## ORIGINATION FORM

Proposed Revisions to a Standard Plans Index  
(Please provide all information — Incomplete forms will be returned)

Index Number: 102-601  
Sheet Number (s): 1  
Index Title: Two-Lane, Two-Way, Work Outside Shoulder

Sheet 1: Revised Detail and Notes (Consolidated with 102-611); Deleted 'Conditions'; Changed Index Title.

| LAST REVISION<br><del>11/01/17</del> | DESCRIPTION: | <br>FY <del>2020-21</del><br>STANDARD PLANS | <del>TWO-LANE, TWO-WAY, WORK OUTSIDE SHOULDER</del> | INDEX<br>102-601 | SHEET<br>1 of 1 |

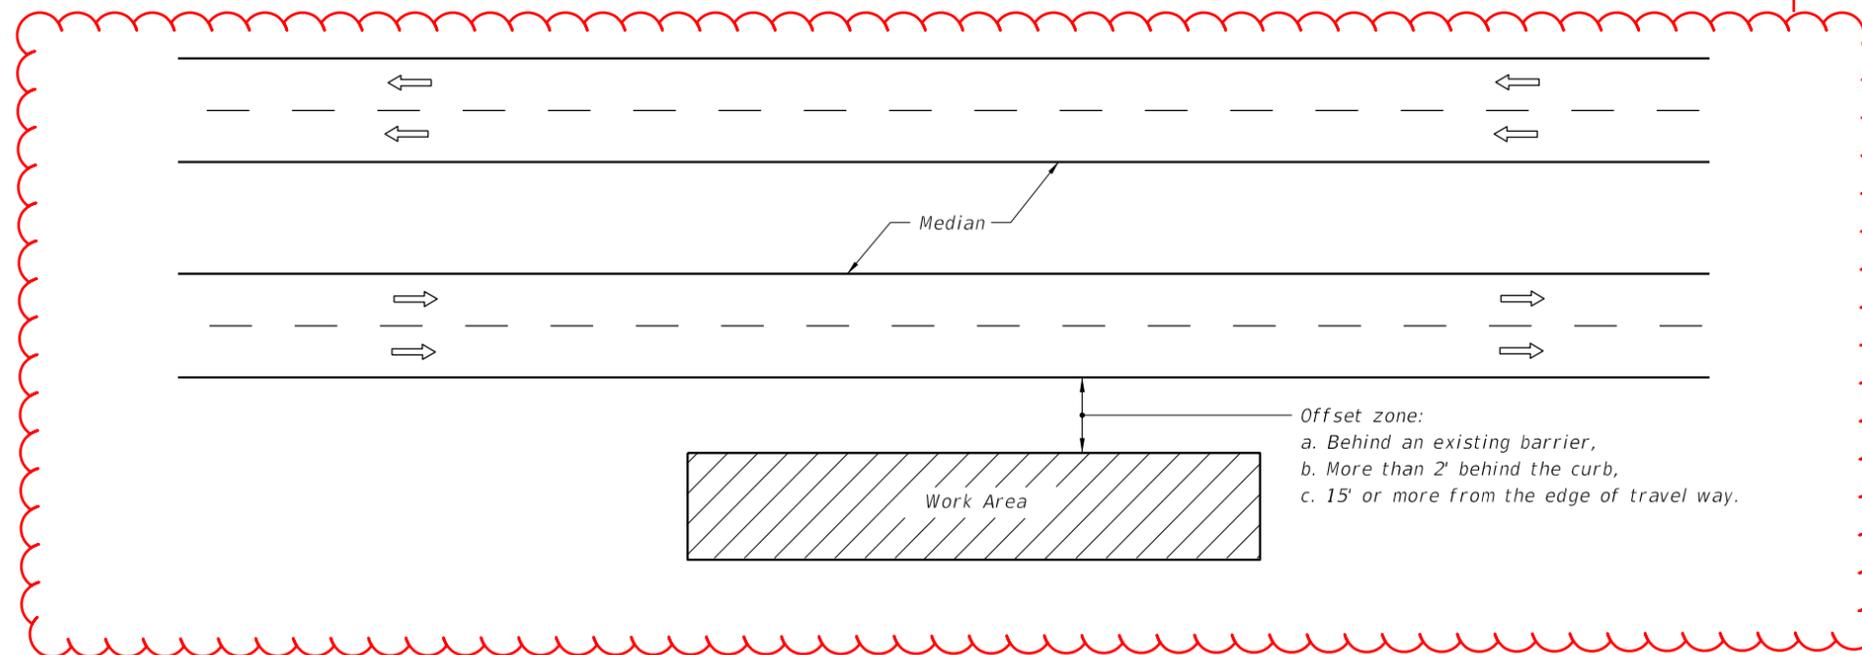
REVISED DETAIL -  
CONSOLIDATED  
WITH INDEX  
102-611

REVISED NOTES  
-  
CONSOLIDATED  
WITH INDEX  
102-611

CHANGED TO "TWO-LANE TWO-WAY AND  
MULTILANE ROADWAY, WORK BEYOND  
THE SHOULDER

| LAST REVISION<br>11/01/20 | REVISION | DESCRIPTION: | <br>FY 2021-22<br>STANDARD PLANS | TWO-LANE AND MULTILANE ROADWAY,<br>WORK BEYOND THE SHOULDER | INDEX<br>102-601 | SHEET<br>1 of 1 |

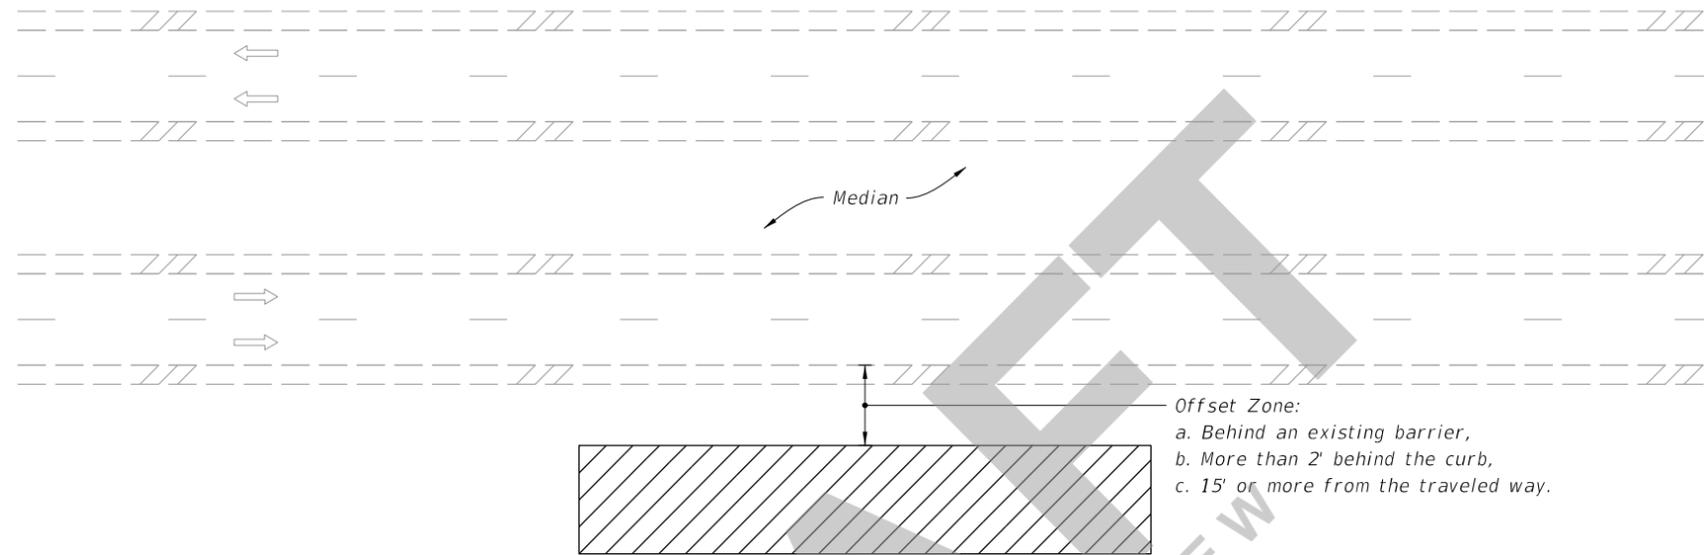
=====**MULTILANE ROADWAY SHOWN, TWO-LANE ROADWAY SIMILAR**=====

1. This Index applies to Two-Lane, Two-Way and Multilane Roadways, including Medians of divided roadways, with work beyond the shoulder.
2. Use Index 102-602 when the work operation (excluding establishing and terminating the work area) requires that two or more work vehicles cross the Offset Zone in any one hour period.
3. Use Index 102-660 when Work Area encroaches a Sidewalk.
